Transmission Expansion Advisory Committee FirstEnergy Supplemental Projects

Changes to the Existing Projects

s1757: Originally presented in 09/28/2018 and 10/26/2018 SRTEP Western meetings
Changes are marked in red

Need Number: ATSI-2018-004 (s1757)
Process Stage: Re-Present Solutions Meeting – 10/8/2024

Beaver #1 ~~and Beaver #2~~ 345/138 kV Transformer Replacement

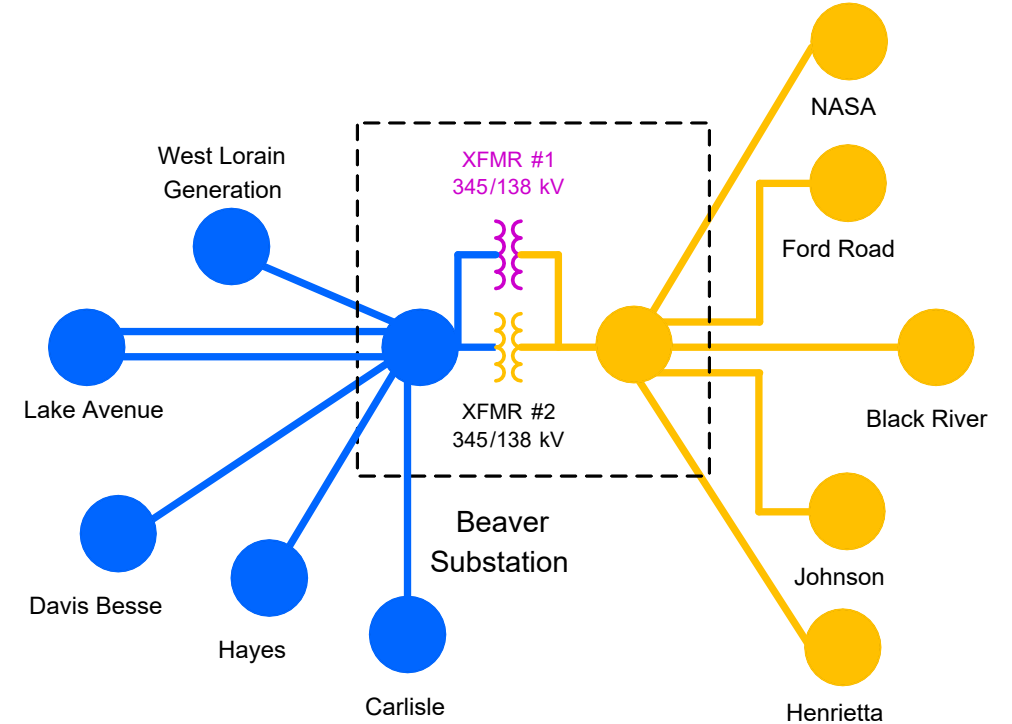
- Replace existing Beaver #1 345/138/13.2 kV transformer (350 MVA) with new 345/138/13.2 kV transformer (448 MVA)
- ~~Replace existing Beaver #2 345/138/13.2 kV transformer (350 MVA) with new 345/138 kV transformer (448 MVA)~~
- ~~Install new 138/13.2 kV transformer (14MVA) and breaker for power to station service at Beaver~~
- ~~Install new 138/13.2 kV transformer (14MVA) and breaker for power to station service at West Lorain Generation~~

Beaver Substation – Terminal equipment to be replaced include:

- Replace disconnect switches, VT’s, CCVT’s, and associated relaying.

- Beaver #1 345/138 kV Transformer:
 - Before Proposed Solution: 498 / 642 / 606 / 702 MVA (SN/SE/WN/WE)
 - After Proposed Solution: 577 / 700 / 682 / 777 MVA (SN/SE/WN/WE)

ATSI Transmission Zone M-3 Process Beaver No. 1 345/138 kV Transformer

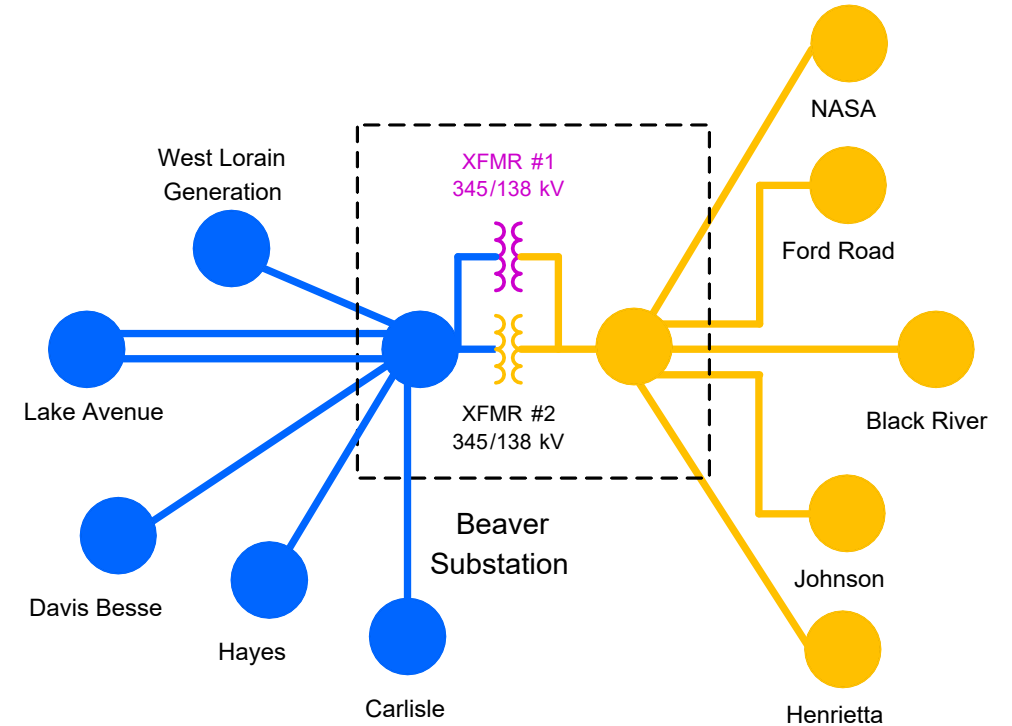
Estimated Project Cost: ~~\$12.7M~~ 10.0 M

Projected IS Date: ~~12/31/2021~~ 4/23/2029

Status: ~~Conceptual~~ Engineering
